Applies To: **2007 MDX** – ALL
2008 MDX – From VIN 2HNYD2...8H500001 thru 2HNYD2...8H504999

MID or Navi Shows a Check Engine Oil Level Message, Low Oil Pressure Indicator May Be On

(Supersedes 09-012, dated March 13, 2009, to revise the information marked by the black bars)

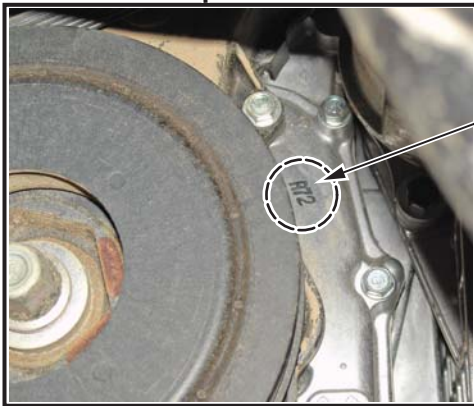
3. Detach the front clip from the right front inner fender. Pull back the edge of the inner fender, and look for an "R72" mark on the right side of the oil pump:
 - If the oil pump has the "R72" mark, use P/N 37240-R72-A01 for the new engine oil pressure switch.
 - If the oil pump does not have the "R72" mark, use P/N 37240-RDM-A01 for the new engine oil pressure switch.

Look for an "R72" mark on the right side of the oil pump.

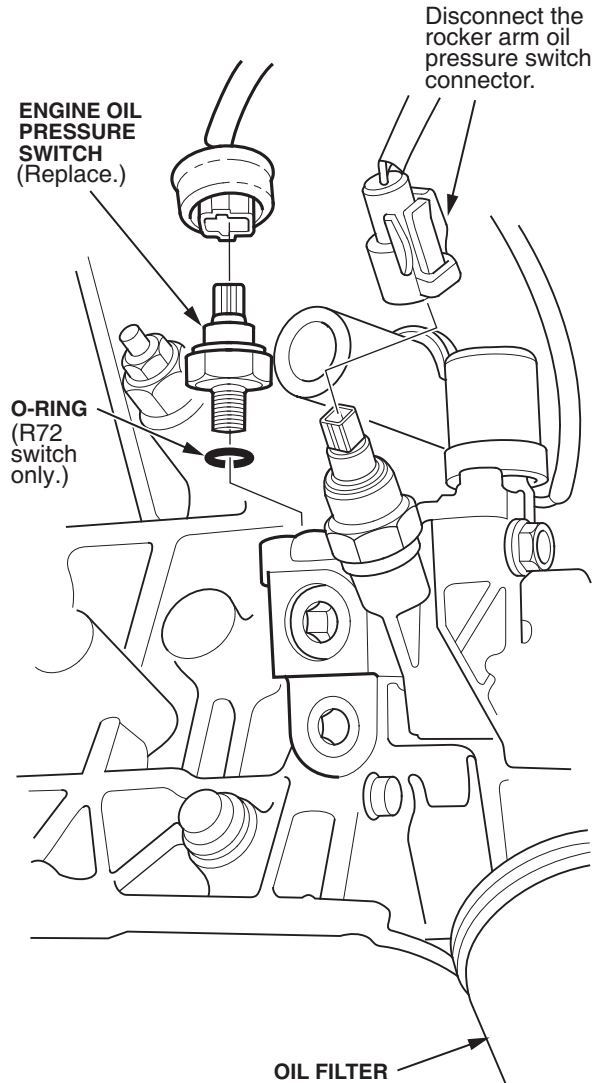
5. For easier removal of the engine oil pressure switch, disconnect the rocker arm oil pressure switch connector.

6. Disconnect the engine oil pressure switch connector, then remove the switch.
7. Remove any liquid gasket from in or around the switch hole.
8. Apply a very thin layer of liquid gasket to the threads of the new switch. *R72 switch only: Install an O-ring.* Install the switch, and torque it to **18 N·m (13 lb-ft)**.
9. Reconnect the engine oil pressure switch connector and the rocker arm oil pressure switch connector.

Under PARTS INFORMATION and REPAIR PROCEDURE, an O-ring for the R72 engine oil pressure switch was added.
